MIDVALE PLANNING AND ZONING COMMISSION MEETING AGENDA MARCH 23, 2016

Planning and Zoning Commission Staff Report

APPLICATION:	Riverwalk Retail Lot 8 Multi-tenant building
LOCATION:	7111 South Bingham Junction Blvd.
APPLICANT:	Wadsworth Development Marty Biljanic, Project Manager
FILE #:	SSMP-21-26-226-012
REQUEST:	Small Scale Master Plan / Preliminary Site Plan
MEETING DATE:	Wednesday, March 23, 2016
ZONING DESIGNATION:	Bingham Junction/Riverwalk Overlay (BJ/RWO) – Subarea 5
AUTHOR:	Matt Hilderman, Associate Planner
APPLICABLE ORDINANCE (S):	17-7-9, 17-7-9.12.1
AGENDA #:	1

SITE PLAN

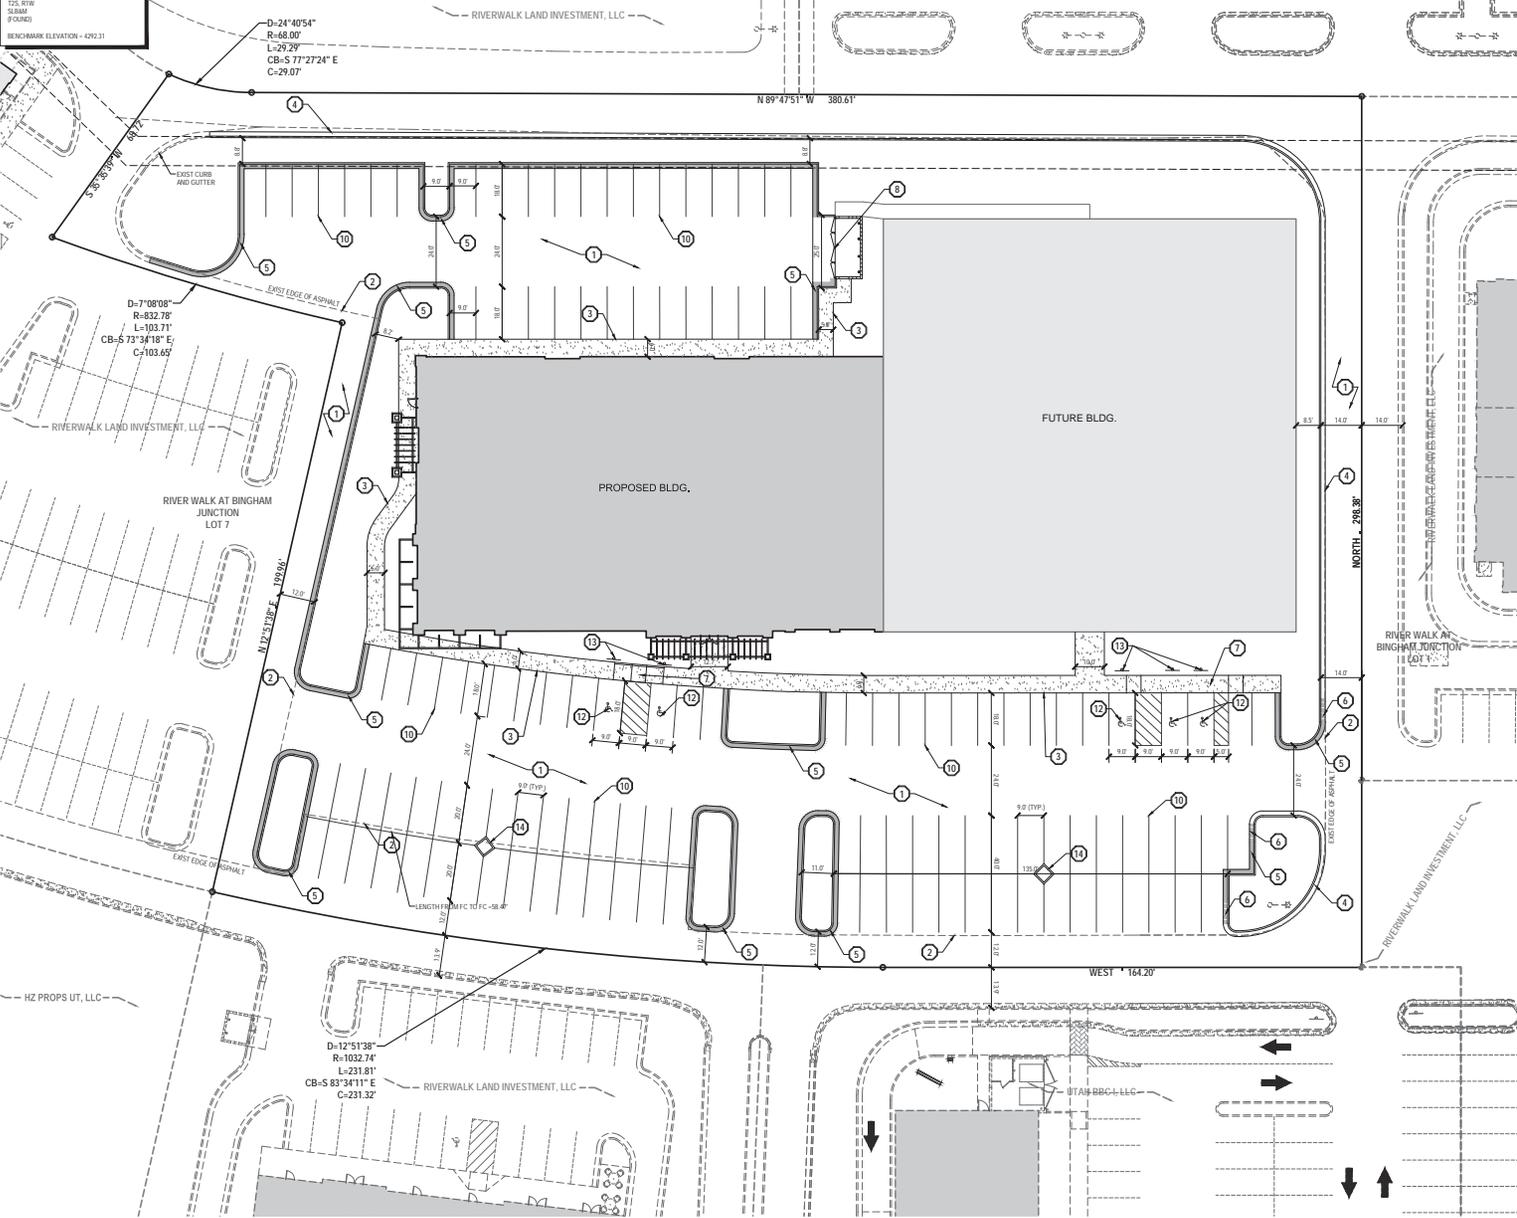
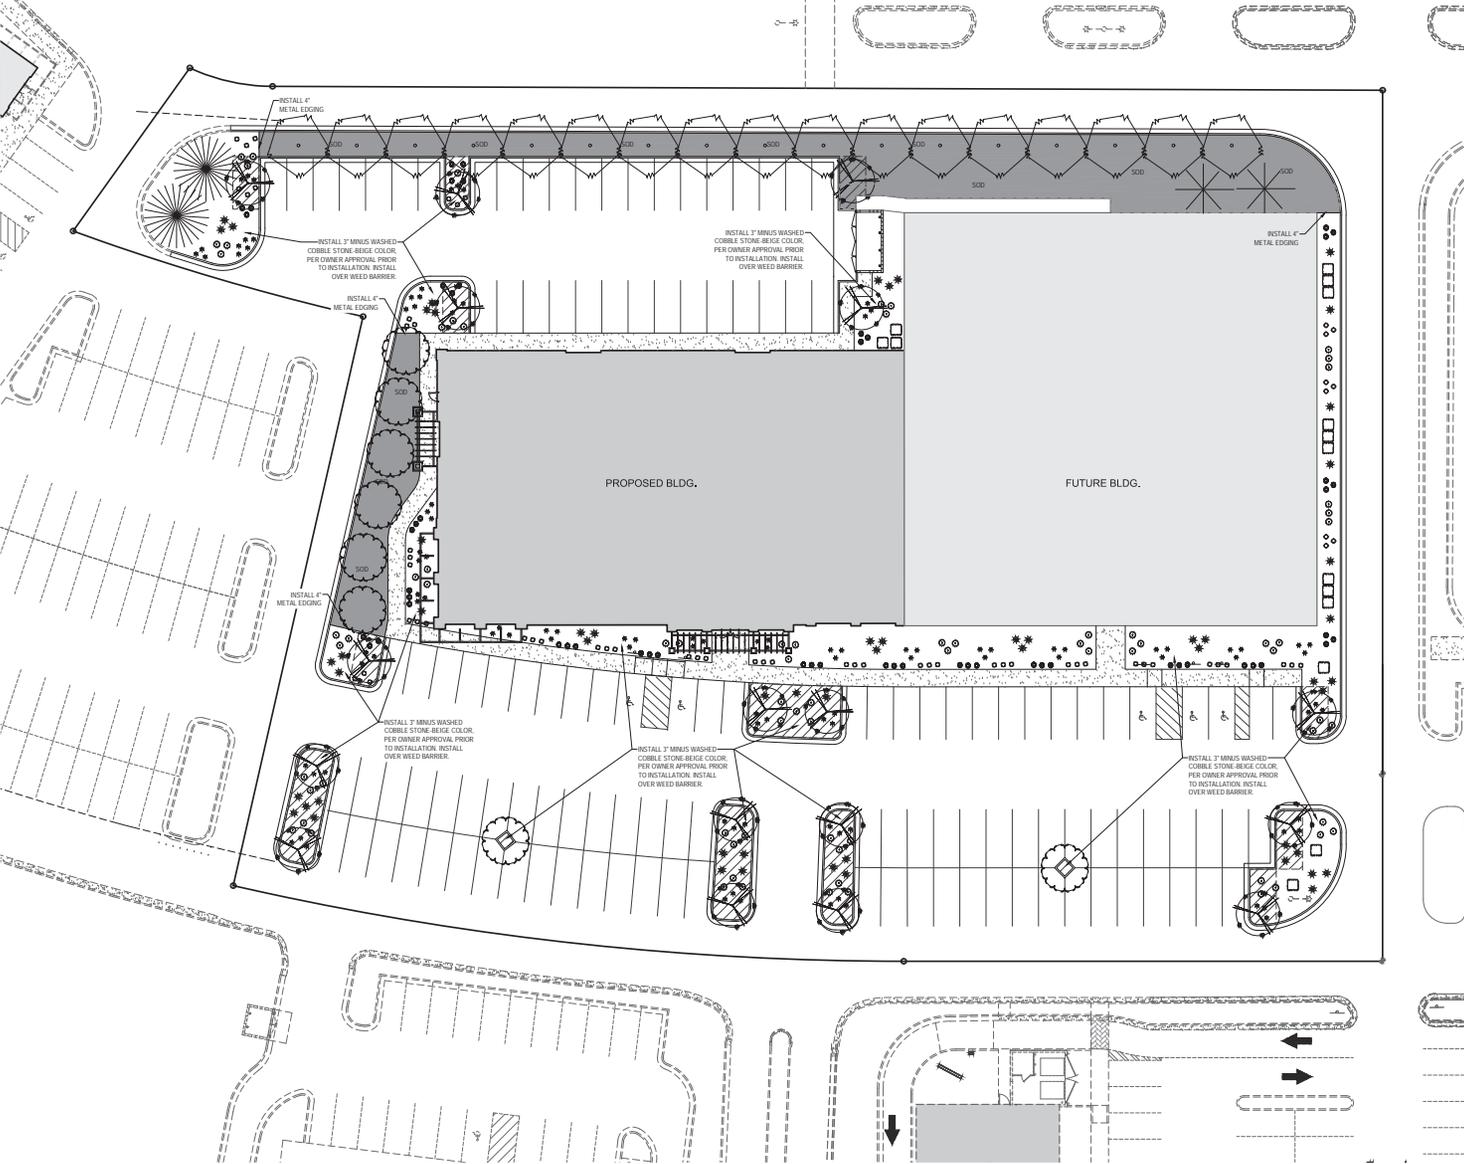
In reviewing the proposed site plan and building elevations with regard to the required development standards, landscaping standards, architectural standards, and Riverwalk Thematic Elements, Staff has found the proposed site plan to comply with the required items. As stated in the Riverwalk Zone development standards, all retail/office/flex structures shall have at least fifty percent (50%) of the adjacent facades built within three feet (3') of the landscaped setback (build-to-line). The build-to line is defined as the landscaped setback line from the public right-of-way. However, since these structures do not front along a public right-of-way, this build-to line requirement is not required. For reference purposes, the 'Proposed Building' is seventy-four feet (74') from the top, back-of-curb of the north access drive and the 'Future Building' is twenty-seven feet (27') from the top, back-of-curb of the north access drive.

The proposed sizes and uses of the buildings require a total of 105 parking spaces; 125 have been provided. The additional landscaping features; i.e. sod areas, cobblestone mulch, and trees and shrubs are proposed to correspond with the adjacent developments within this area. Building foundation landscaping has also been provided around the perimeters of each structure. The applicant has also provided 14% interior parking lot landscaping which complies with the minimum 10% interior parking lot landscaping requirement. One issue that will need to be adjusted is the proposed parking spaces adjacent to the 'Future Building' site. The ordinance requires for parking areas over fifteen (15) spaces; a landscaped island shall be required. The applicant shall either propose a landscaped island for every 15 parking spaces or remove additional parking spaces to comply with the ordinance requirement.

1. *Prior to construction of the ‘Future Building’ the applicant shall submit plans for further review and approval by the Planning Commission.*
2. *The applicant shall either propose a landscaped island for every 15 parking spaces or adjust the parking spaces adjacent to the ‘Future Building’ site in order to comply with the ordinance requirements.*

**ARCHITECTURAL
 ELEVATIONS**

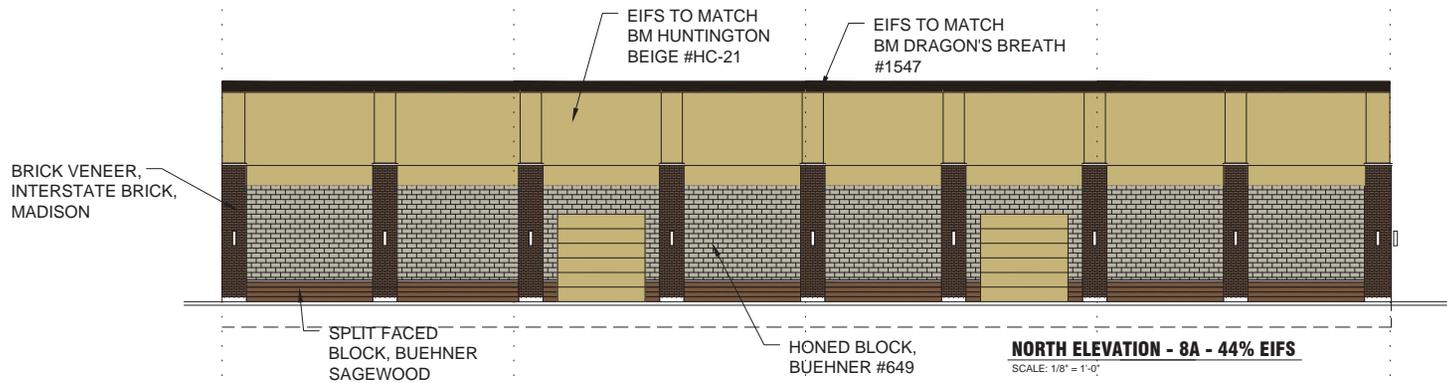
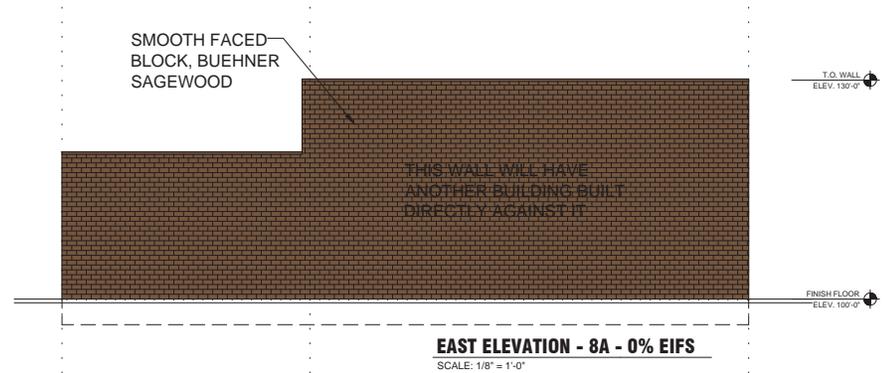
The proposed building includes some of the building forms, materials, and colors included in the Exterior Building Palette which is part of the approved Development Agreement for the overall project. The structures also include variations in the facades and details that break up the wall areas.

All mechanical equipment located on the outside of the building shall be painted to match the structure and/or screened appropriately with landscaping. The Riverwalk Overlay limits the amount of stucco on

exterior elevations to a maximum of 50%. All elevations comply with this standard. Other items that need to be addressed include:

3. *All mechanical equipment is encouraged to be located inside the building. Any equipment, meters/boxes, etc. required to be on the outside of the building shall be painted to match the building and/or screened appropriately with additional landscaping.*
